Docket Item # 14 & 15
BAR CASE # 2012-0269 &
2012-0270

BAR Meeting
September 5, 2012

ISSUE: Partial Demolition/Capsulation & Addition/Alterations

LOCATION: 823 South Columbus Street

EAST ELEVATION - DEMO. & ENCAPSULATION
 3/16" = 1'-0"

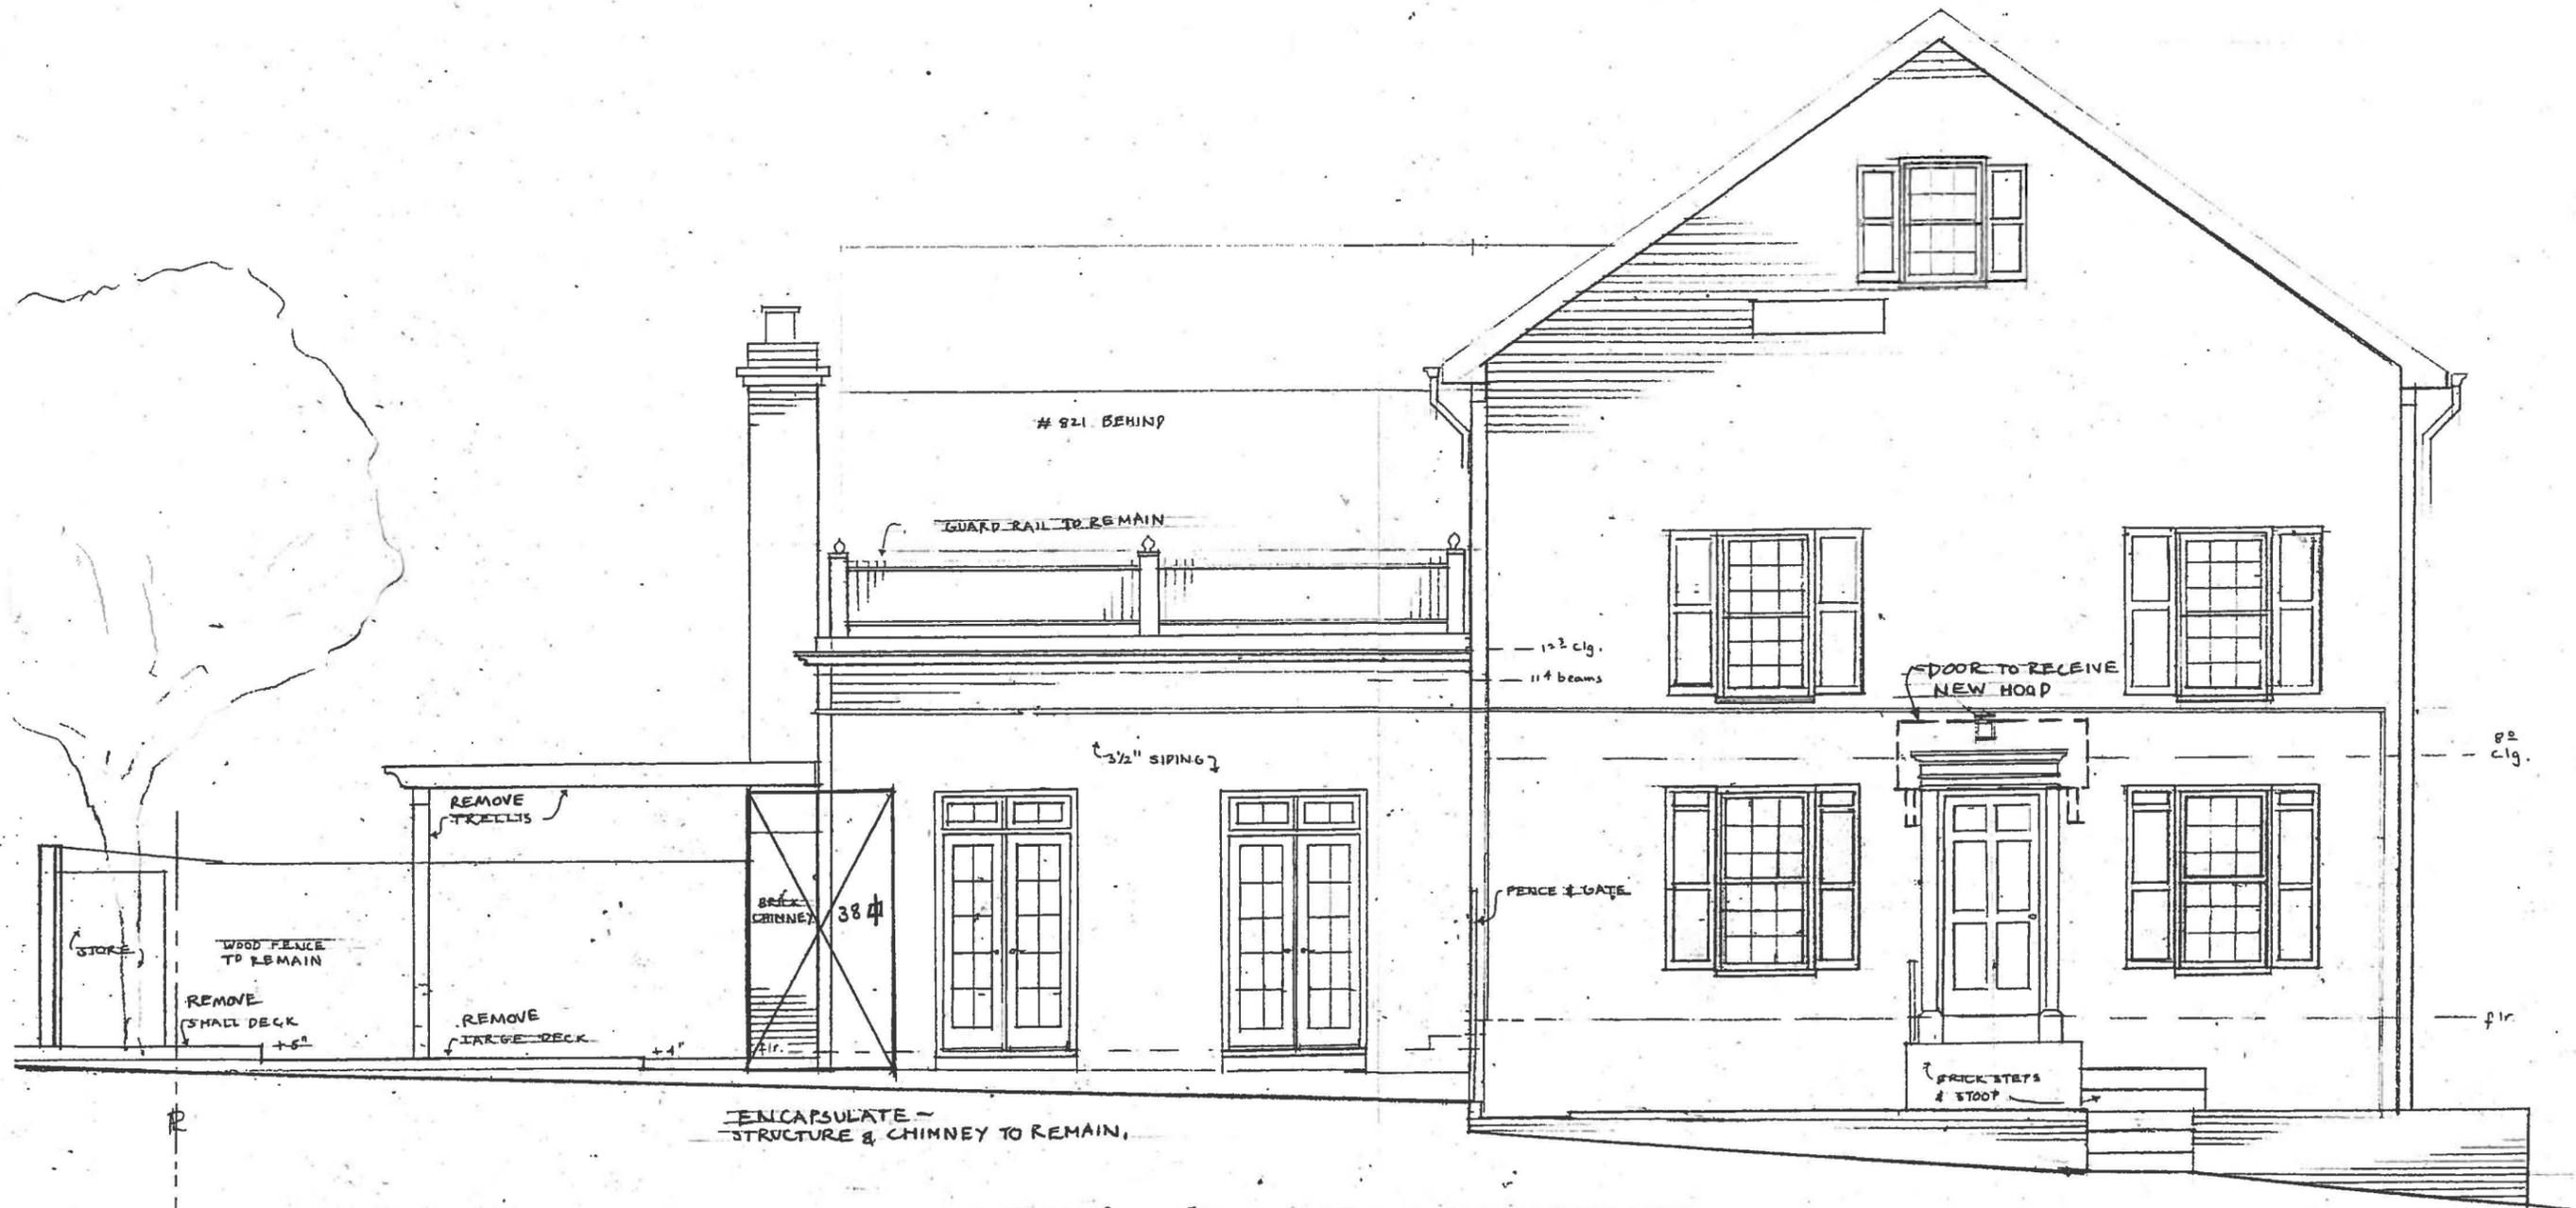
The applicant is requesting approval of a Permit to Demolish/Capsulate to demolish a portion of the rear wall and fireplace, as well as a portion of the front façade at 823 South Columbus Street in order to accommodate a new, one-story rear addition and a front bay window/door. The area of demolition is 288 feet. The rear addition will consist of two volumes, one with a shed roof on the north property line measuring 11.5 feet by 9.3 feet and another, larger gable-roof building mass measuring 19 feet by 13.5 feet. The smaller block of the addition will have three French doors and two skylights. The gable roof portion will have two double hung, 6-over-6 windows with shutters on the south elevation and a single matching window on the north elevation.

In the opinion of Staff, the criteria to demolish and capsulate are not met and the Permit to Demolish/Capsulate should be granted. The Board regularly approves the partial demolition of rear elevations to allow for additions when they are not of particularly old or unusual construction. In this case, the existing rear addition and chimney date from the late 1970s and early 1980s when the 1950s building was drastically modified. No distinguishing architectural characteristics will be lost with the proposed demolition/capsulation.

WEST ELEVATION - DEMO. & ENCAPSULATION
 3/16" = 1'-0"

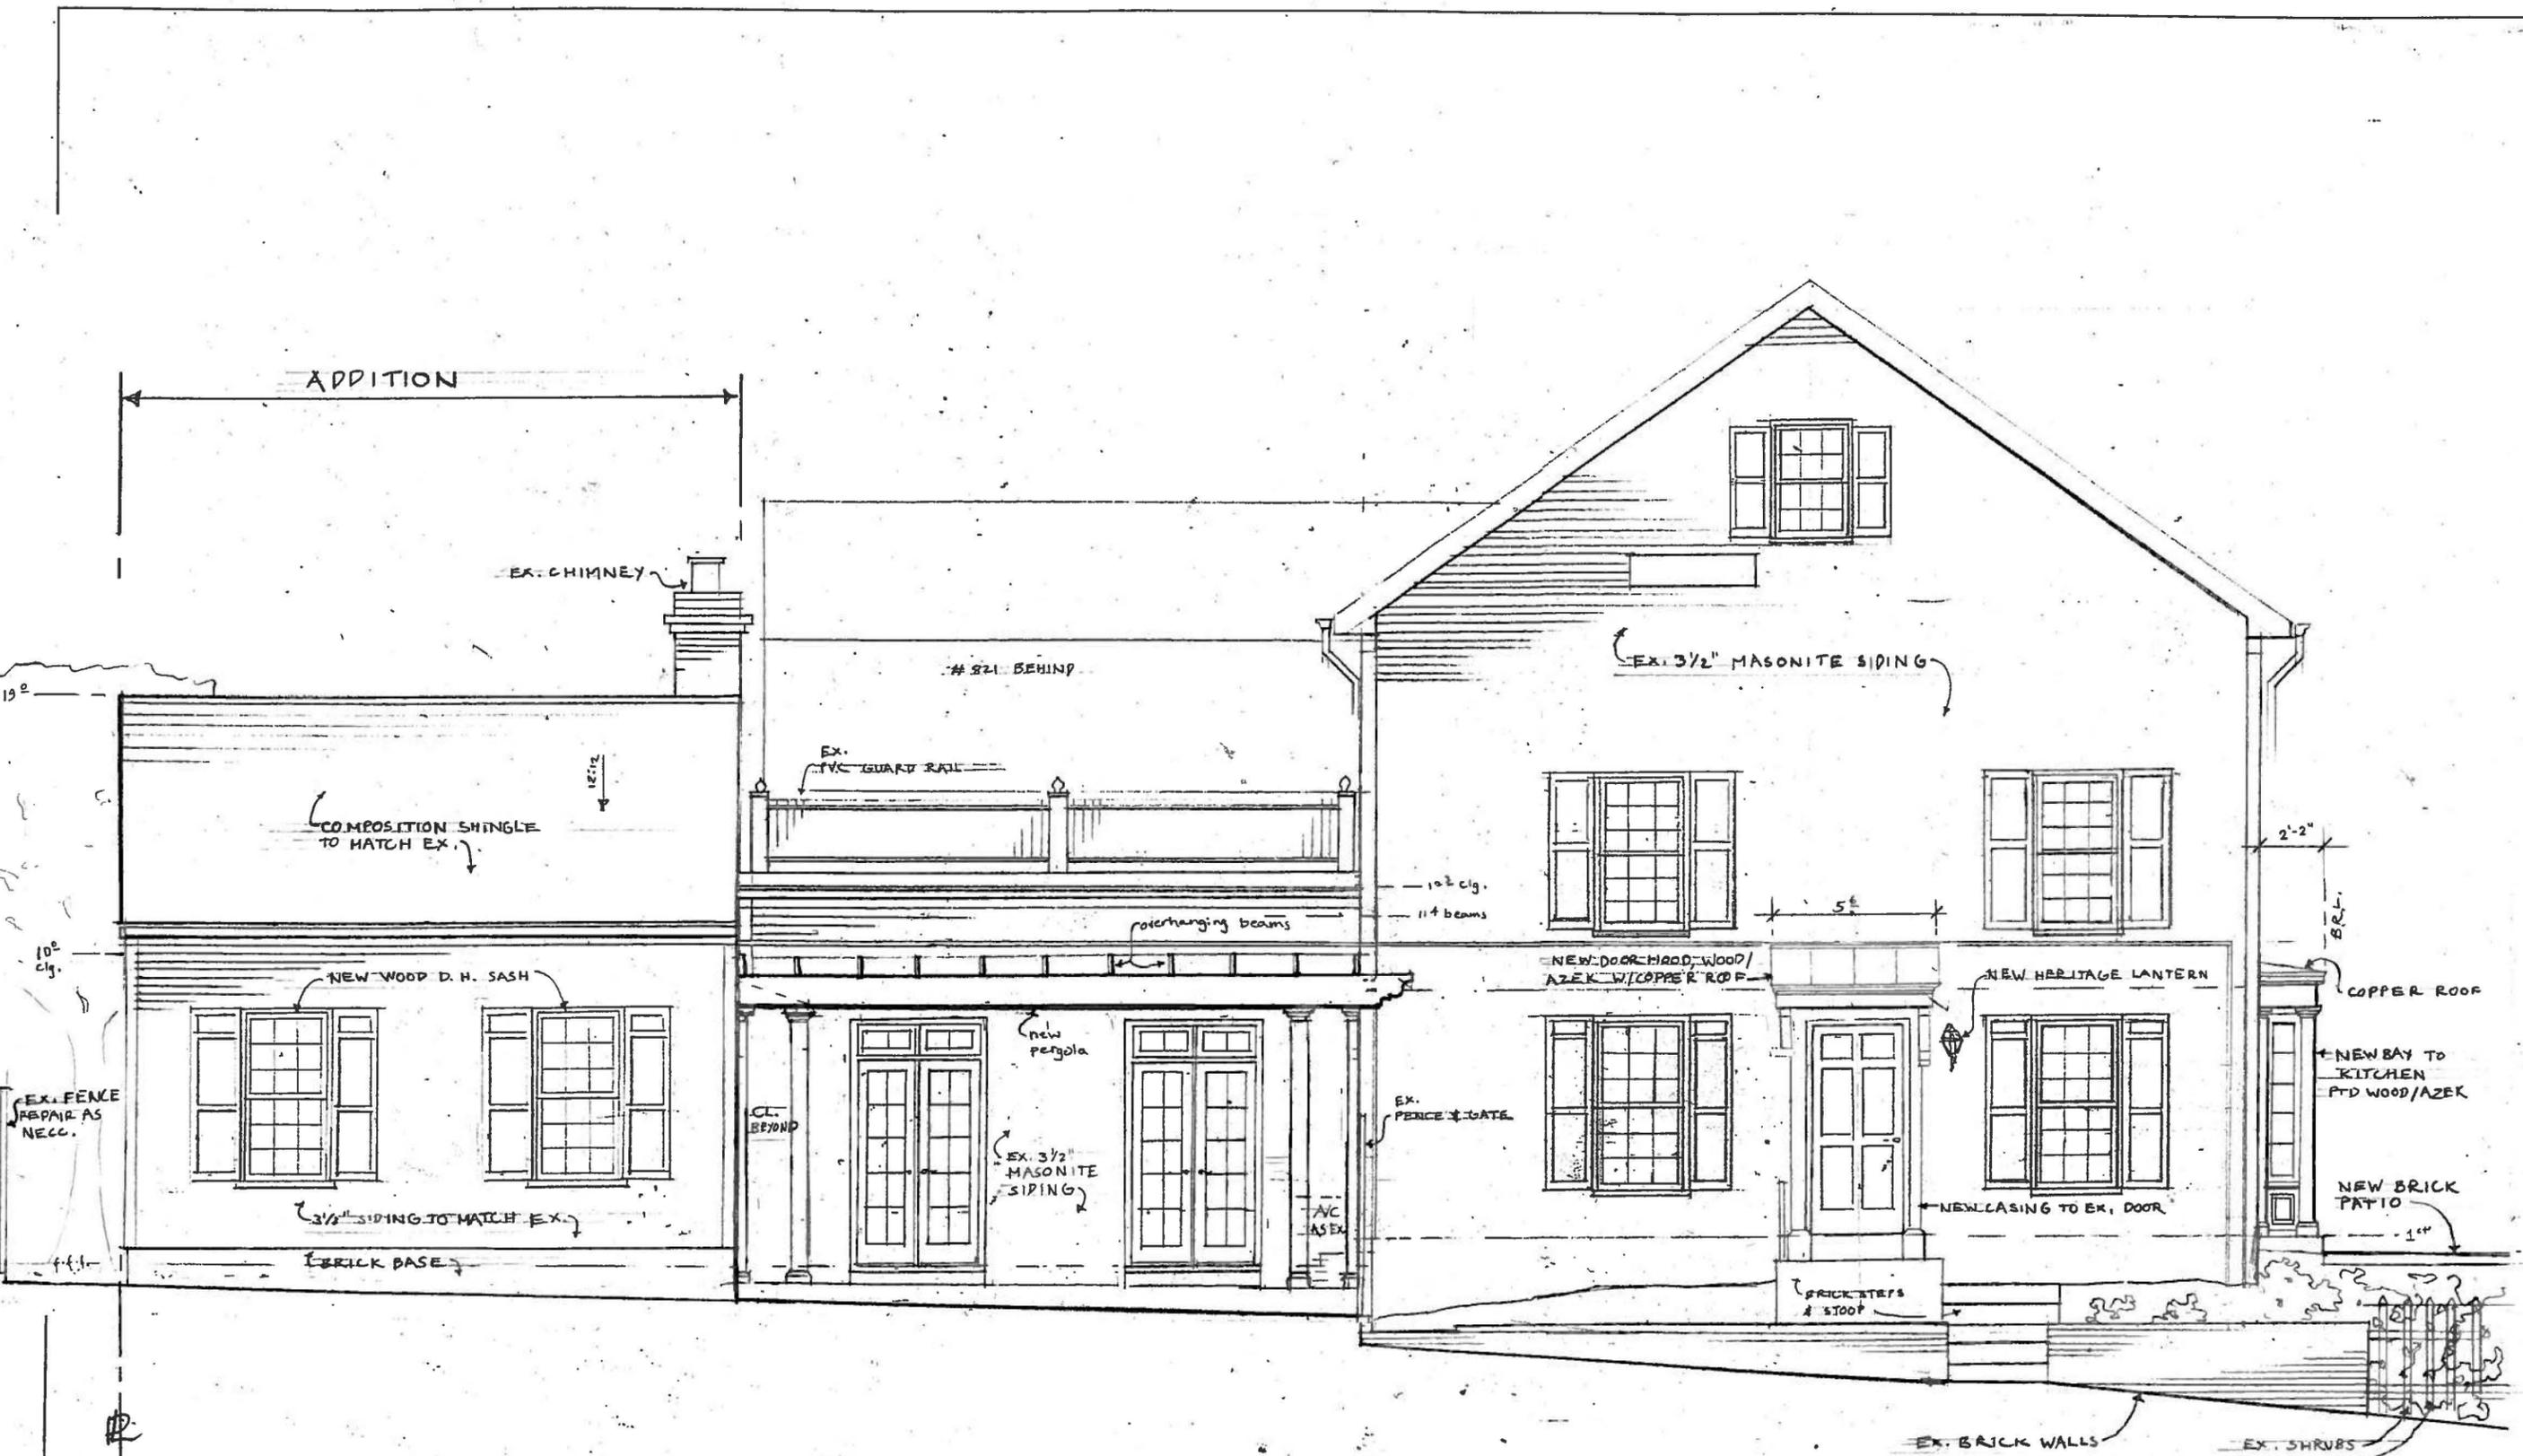
ENCAPSULATE -
STRUCTURE & CHIMNEY TO REMAIN.
